1 SOUTH ELEVATION
 SCALE: 1/4" = 1'-0"

DATE of APPROVAL: **10-4-2016**
 PLANNER: **Jean Fraser**
 PROJECT NO.: **#2016-016**

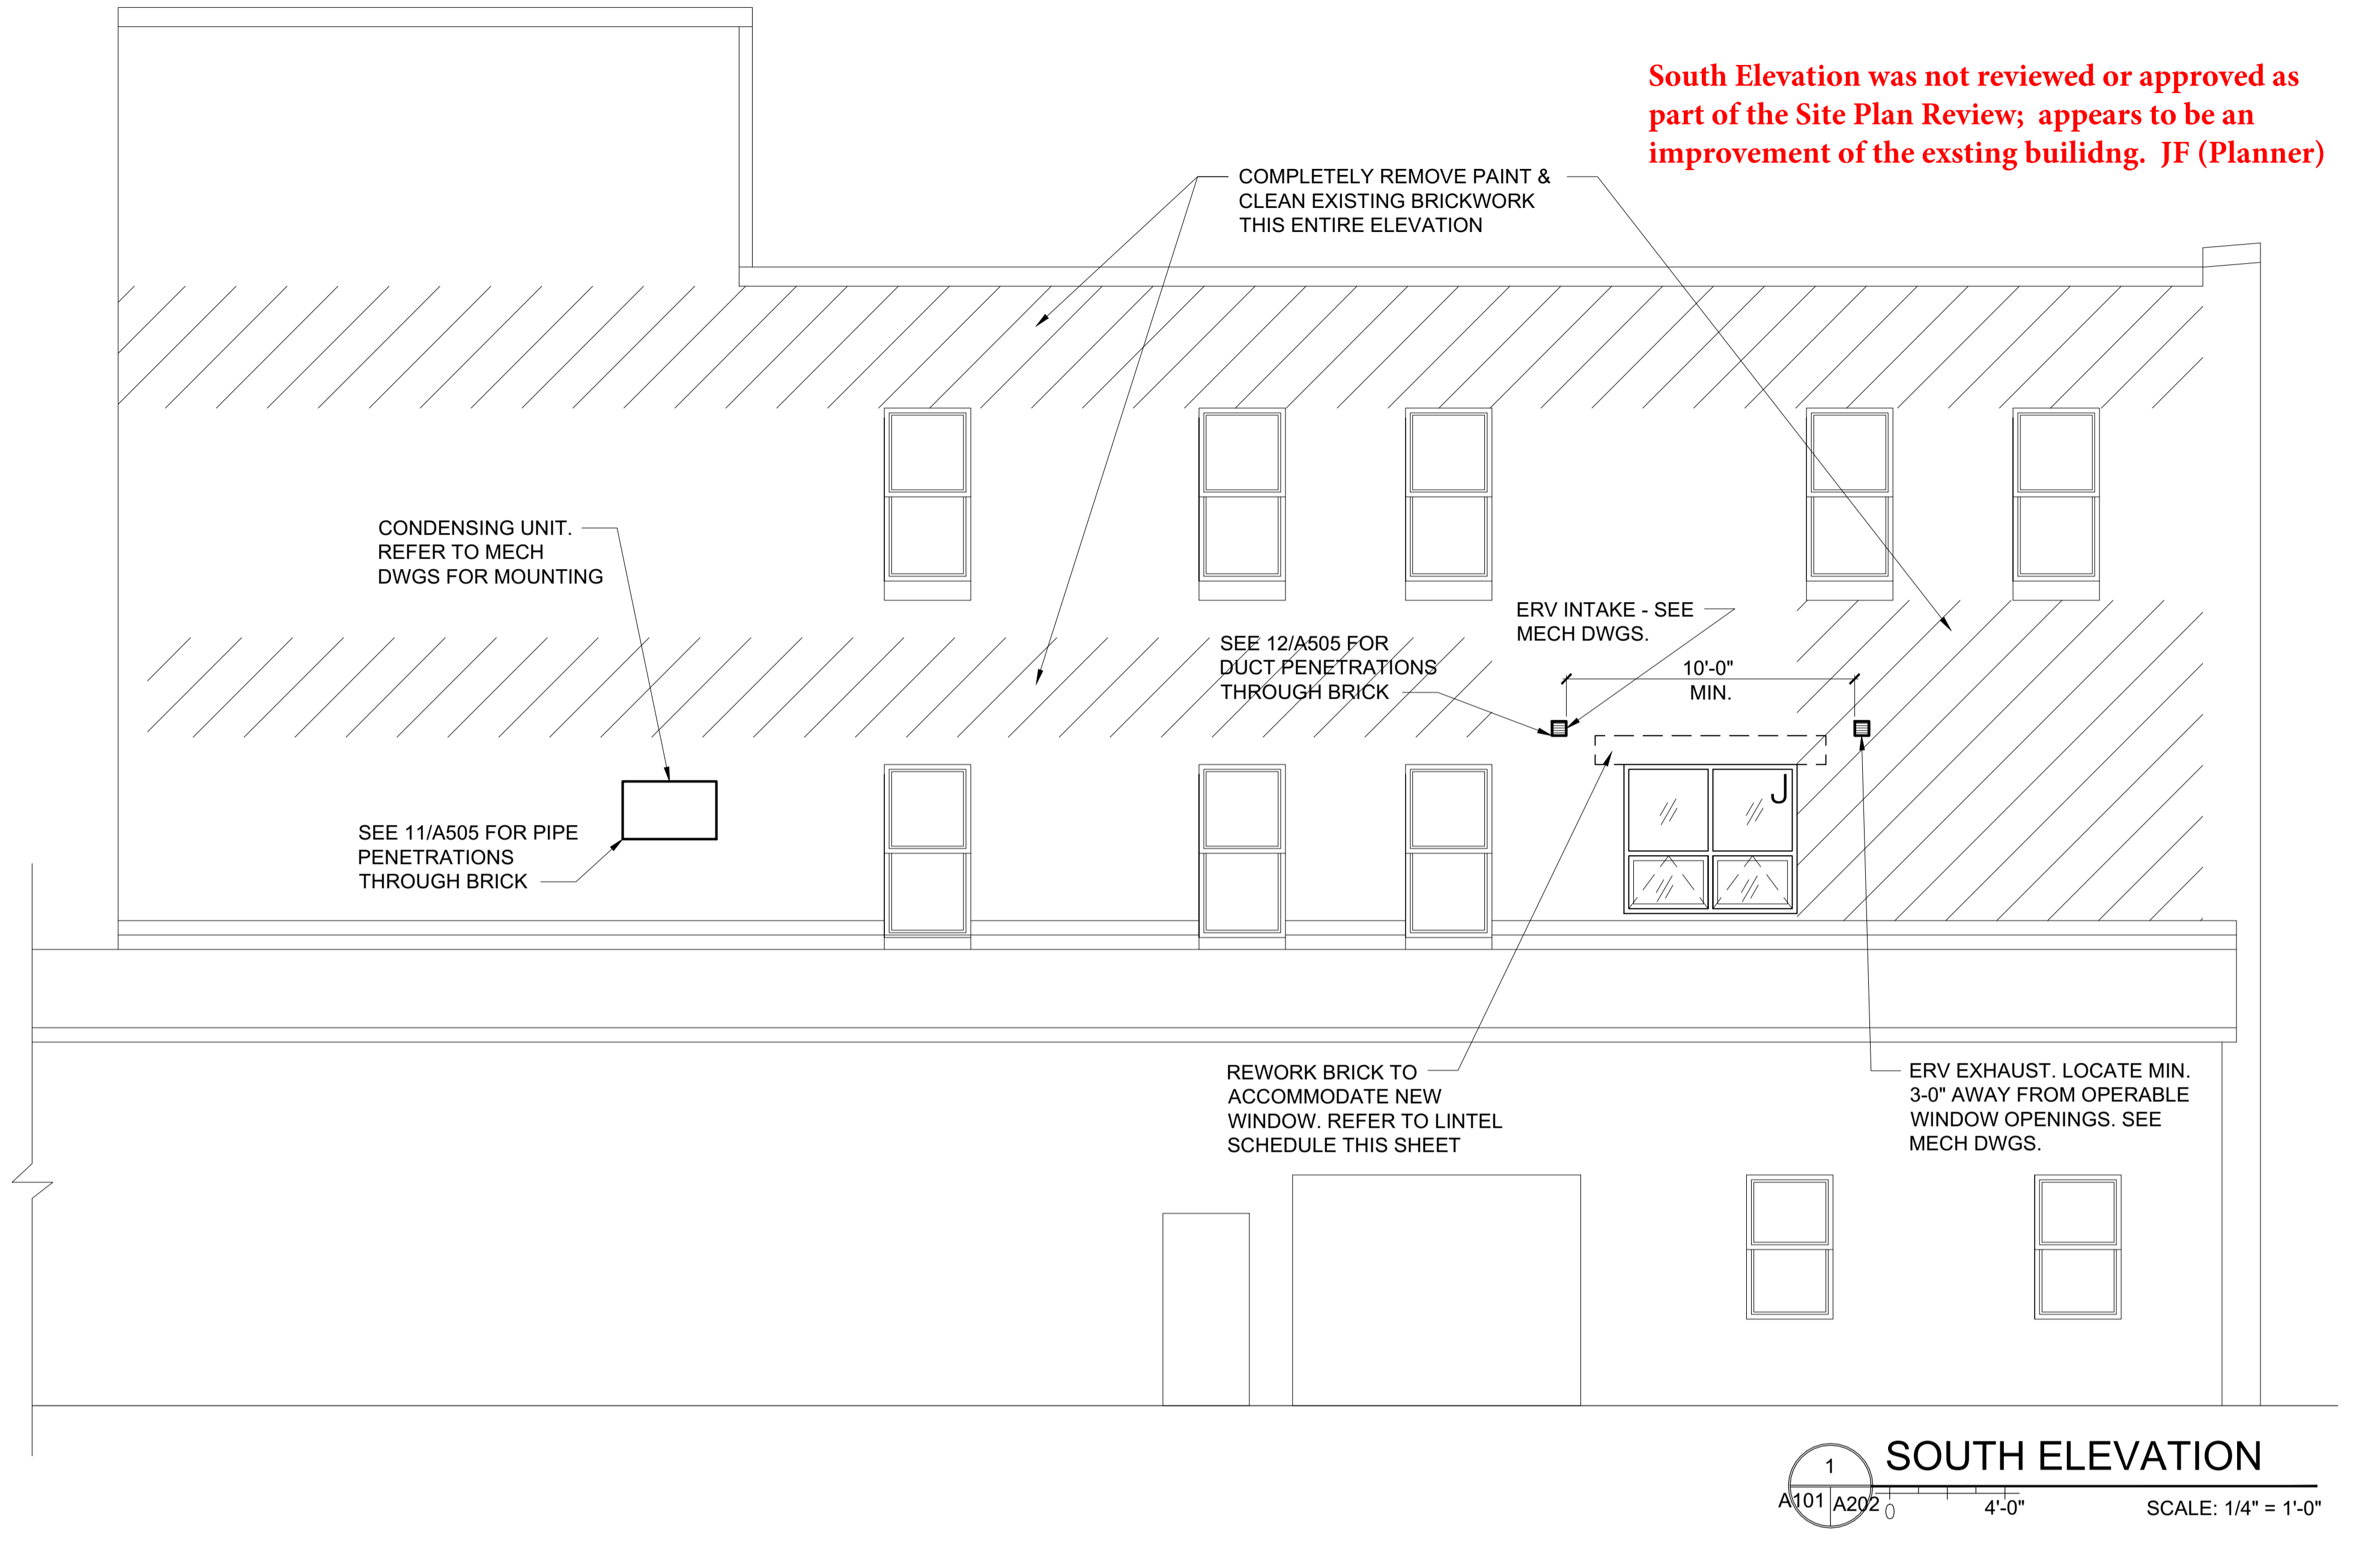
South Elevation was not reviewed or approved as part of the Site Plan Review; appears to be an improvement of the existing building. JF (Planner)
